DEVELOPMENT REVIEW COMMITTEE (DRC) COMMENT REPORT

PROJECT NAME: Riverland Park

CASE NUMBER: R19065

REQUEST: Site Plan Level III – Conditional Use Request to Increase Height for Light Poles From 60 Feet to 70 Feet in Park (P) District

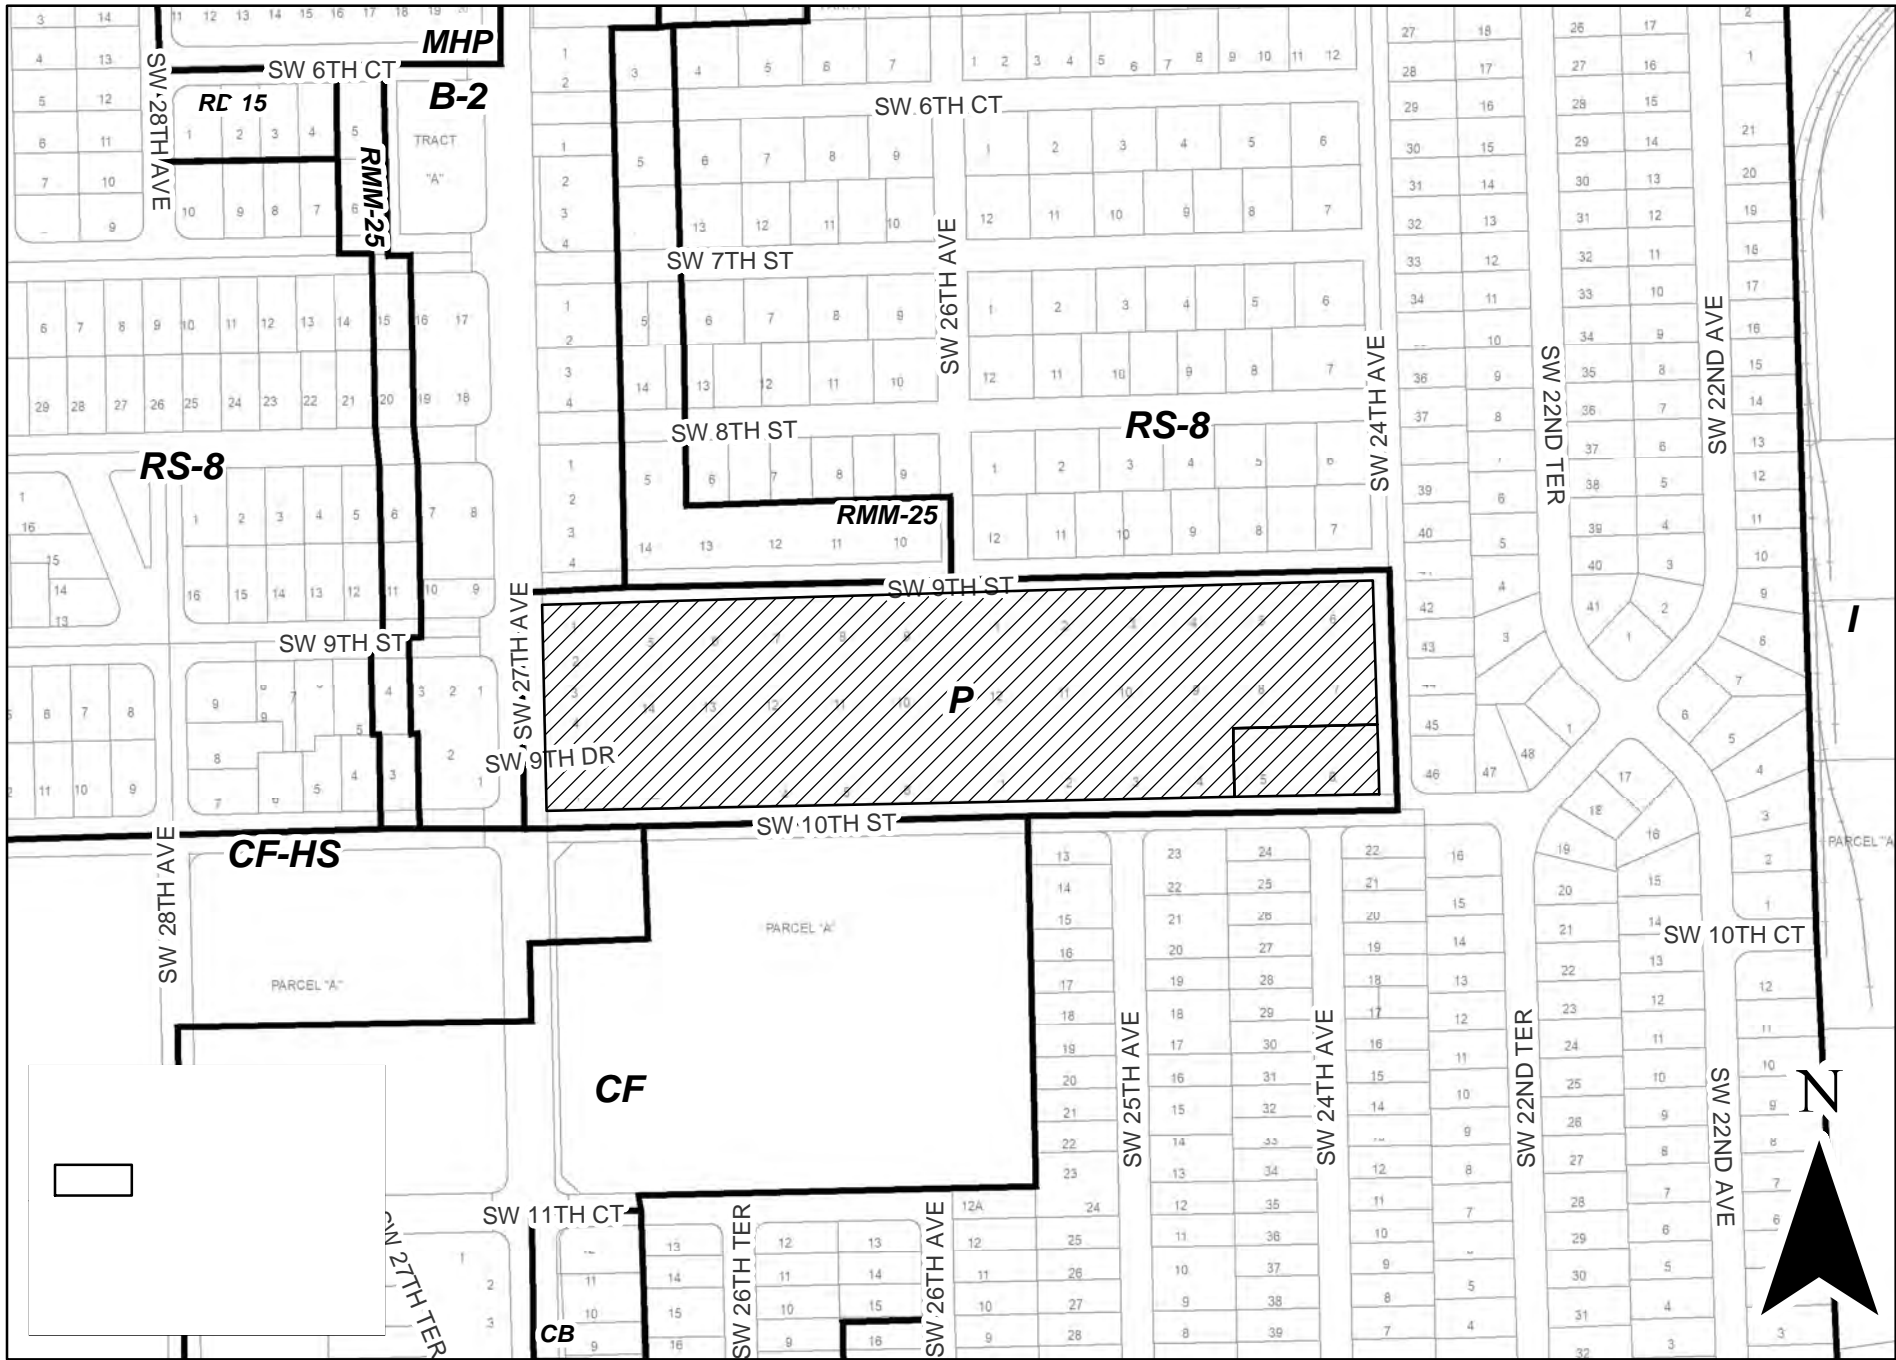
- 6) Provide legible photometric plan for the entire site. Extend values on photometric plans to all property lines. Show values pursuant to the Unified and Land Development Regulations ("ULDR"), Section 47-25.3.A.3.a and 47-20.14. Indicate lighting poles on site plan and landscape plan, and provide detail with dimensions. Garage internal lighting fixtures and glare cannot be visible from neighboring properties.

Indicate lighting poles on site plan and landscape plan, and provide detail with dimensions. Be aware that lighting fixtures greater than ten (10) feet in height are used, they shall be located a minimum of fifteen (15) feet away from shade trees (Sec. 47-20.14)
